The Bidders Conference for the Sir Wilfred Grenfell 2013 Dry Docking Refit was convened on 21 November 2012 at 13:30 hours with the following officials in attendance:

CCGS Sir Wilfred Grenfell Drydocking Refit

Bidder's Conference Amendments

Gyro picture 2 revised

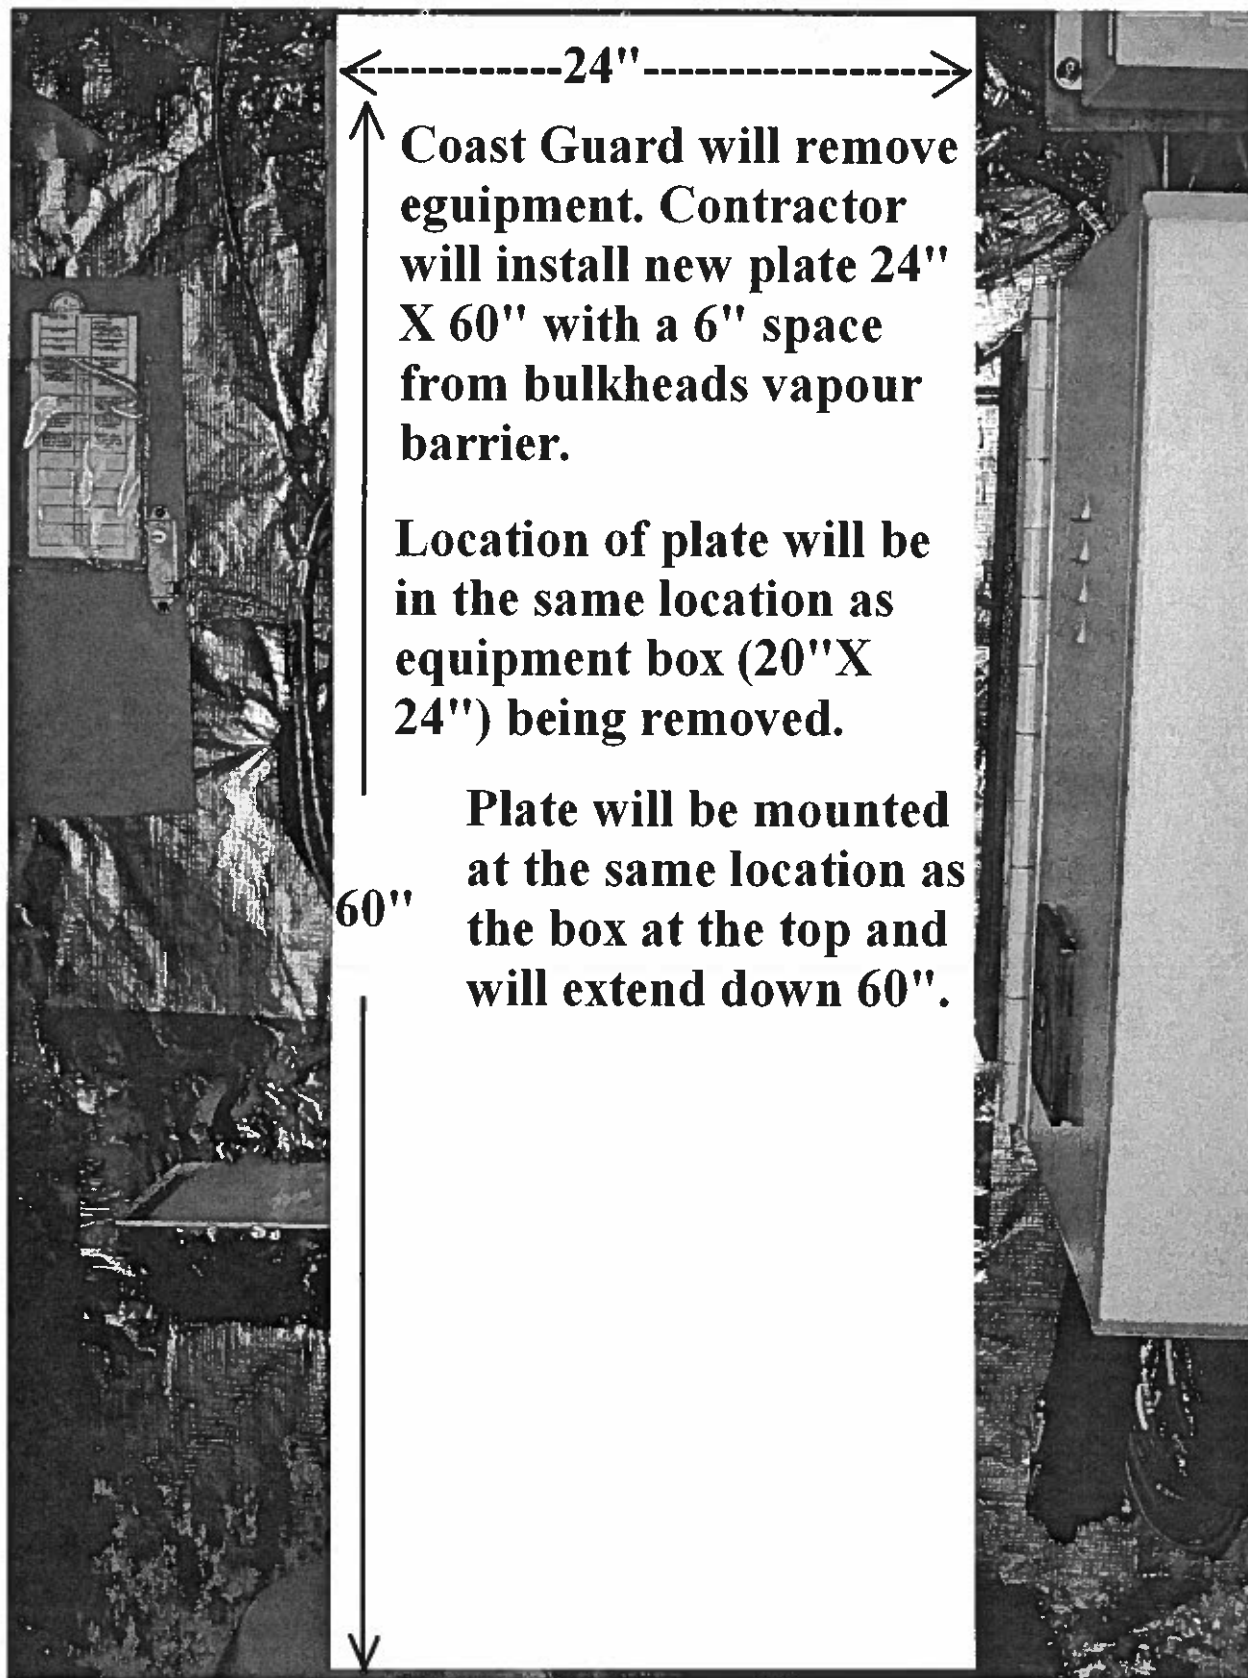
3.1.1 **Amendment:** Underlined text added: The lower bridge deck alley way and stair well is below the area where welding is to take place. Deckhead tiles in this area will require removal for access to insulation for removal & re installation. **Amendment:** Underlined text added: The second and fourth pictures will be replaced by Gyro picture 2 revised and Gyro picture 4 revised.

Coast Guard will remove equipment. Contractor will install new plate 24" X 60" with a 6" space from bulkheads vapour barrier.

Location of plate will be in the same location as equipment box (20" X 24") being removed.

Plate will be mounted at the same location as the box at the top and will extend down 60".
